Product Change Notification / JAON-19HUM0778

CCB 3676.004 and 3676.005 Final Notice: Qualification of MMT as an additional assembly site for selected MCP1725 and MCP1727 device families available in 8L DFN (2x3x0.9mm) and 8L DFN (3x3x0.9mm) packages.

CCB 3676.004 and 3676.005
Pre and Post Change Summary
PCN#: JAON-19HUMO778

Lead frame comparison – 8L DFN (3x3x0.9mm) package

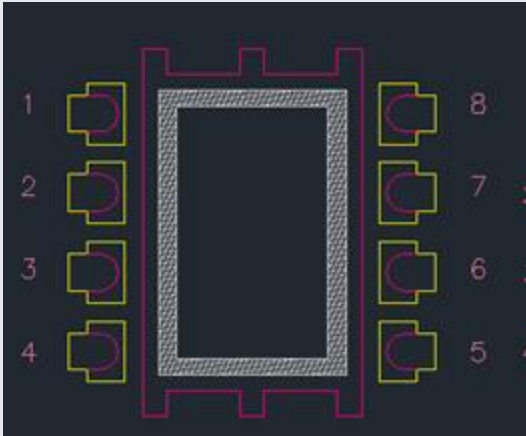
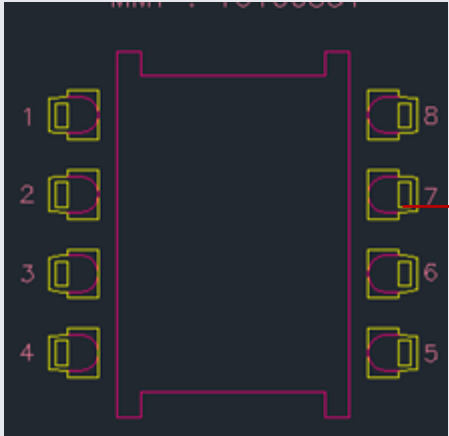
<table><tr><td>Lead frame material</td><td>EFTEC-64T</td></tr><tr><td>Lead frame DAP surface Prep</td><td>Ag</td></tr><tr><td>Lead Lock</td><td>No</td></tr></table>	Lead frame material	EFTEC-64T	Lead frame DAP surface Prep	Ag	Lead Lock	No	<table><tr><td>Lead frame material</td><td>C194</td></tr><tr><td>Lead frame DAP surface Prep</td><td>Bare Cu</td></tr><tr><td>Lead Lock</td><td>Yes</td></tr></table>	Lead frame material	C194	Lead frame DAP surface Prep	Bare Cu	Lead Lock	Yes
Lead frame material	EFTEC-64T												
Lead frame DAP surface Prep	Ag												
Lead Lock	No												
Lead frame material	C194												
Lead frame DAP surface Prep	Bare Cu												
Lead Lock	Yes

Note: The lead lock hole fills with mold compound during the assembly process and provides improved protection against moisture penetration around the interface edges between pins and mold compound.

Lead frame comparison – 8L DFN (2x3x0.9mm) package

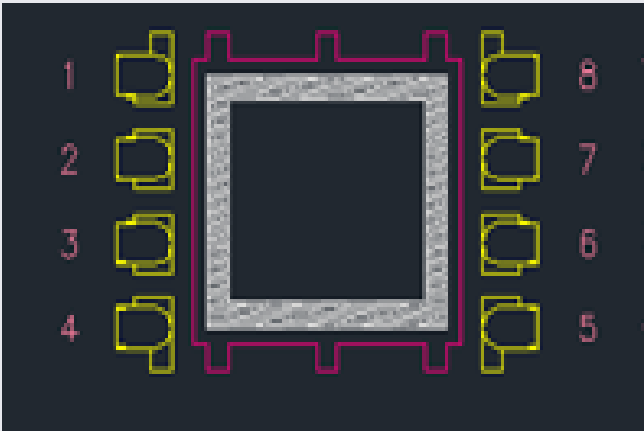
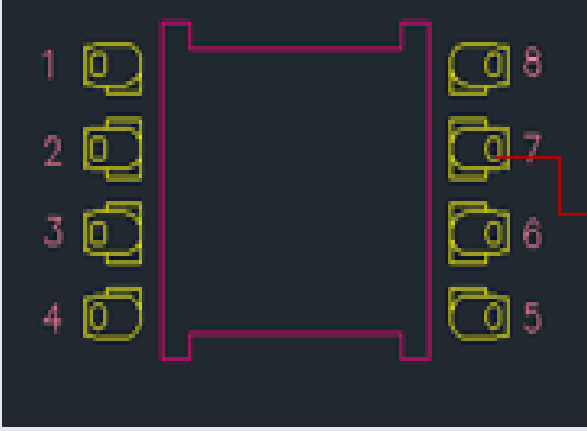
<table><tr><td>Lead frame material</td><td>EFTEC-64T</td></tr><tr><td>Lead frame DAP surface Prep</td><td>Ag</td></tr><tr><td>Lead Lock</td><td>No</td></tr></table>	Lead frame material	EFTEC-64T	Lead frame DAP surface Prep	Ag	Lead Lock	No	<table><tr><td>Lead frame material</td><td>C194</td></tr><tr><td>Lead frame DAP surface Prep</td><td>Bare Cu</td></tr><tr><td>Lead Lock</td><td>Yes</td></tr></table>	Lead frame material	C194	Lead frame DAP surface Prep	Bare Cu	Lead Lock	Yes
Lead frame material	EFTEC-64T												
Lead frame DAP surface Prep	Ag												
Lead Lock	No												
Lead frame material	C194												
Lead frame DAP surface Prep	Bare Cu												
Lead Lock	Yes

Note: The lead lock hole fills with mold compound during the assembly process and provides improved protection against moisture penetration around the interface edges between pins and mold compound.
